锁体技术改进说明

Lock body technology improvement instructions

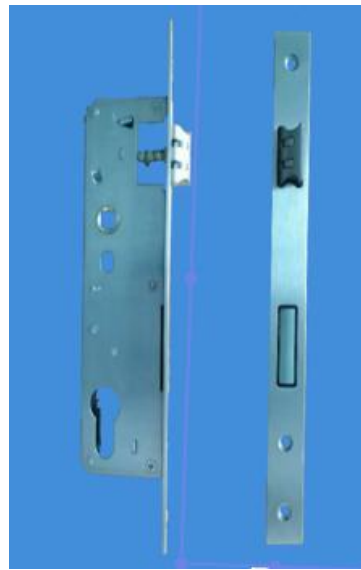
一、区别于常见的滑动锁闭，新款锁体采用新型滚轮结构，使滑动摩擦变为滚动摩擦，使启闭更顺畅。

Different from the common sliding lock, the new lock body adopts a new type of roller structure, which changes the sliding friction into rolling friction, making the opening and closing smoother.
